Spartan Motors Chassis, Inc.

SERVICE BULLETIN

RSB13-260-001

SUBJECT: Spartan Motors Chassis, Inc. has determined a defect relating to steering gear mounting bracket with gussets welded at the lower and top ends may exist in certain vehicles.

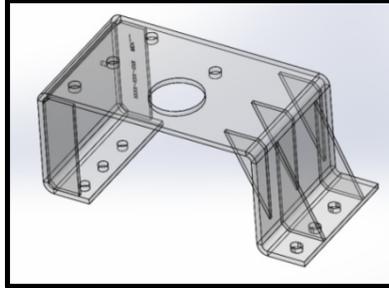
NOTE: The below graphic shows the original steering gear bracket. Occasionally final stage manufacturers attach components to this. If the bracket has additional parts such as angle iron welded to it, please contact Spartan Motors Chassis, Inc., Customer & Product Support.
